# REPORT TO HUNTER & CENTRAL COAST JOINT REGIONAL PLANNING PANEL

TITLE DEVELOPMENT APPLICATION NO. 38097/2010

PROPOSED: RESIDENTIAL FLAT DEVELOPMENT 3-6 STOREY 87 UNITS & DEMOLISH ALL EXISTING BUILDINGS ON LOT: A DP: 361327, LOT: B DP: 361327, LOT: C DP: 361327, 19-21 DONNISON STREET WEST AND 8

FIELDER STREET WEST GOSFORD

## **ATTACHMENT 4 - DEVELOPMENT MONTAGE**

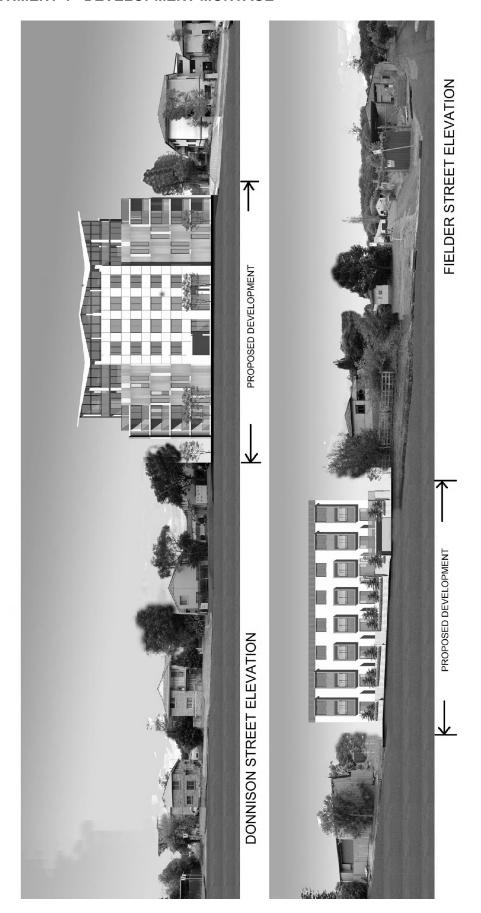
- The proposal cannot rely on landscaping to minimise impact on adjoining properties as the proposed 3-4m side setbacks do not provide sufficient area for appropriate landscaping including larger 10m high trees to aid in minimising the bulk and scale of the building. (Refer refusal reason 5 and Annexure 5 Development Photomontage)
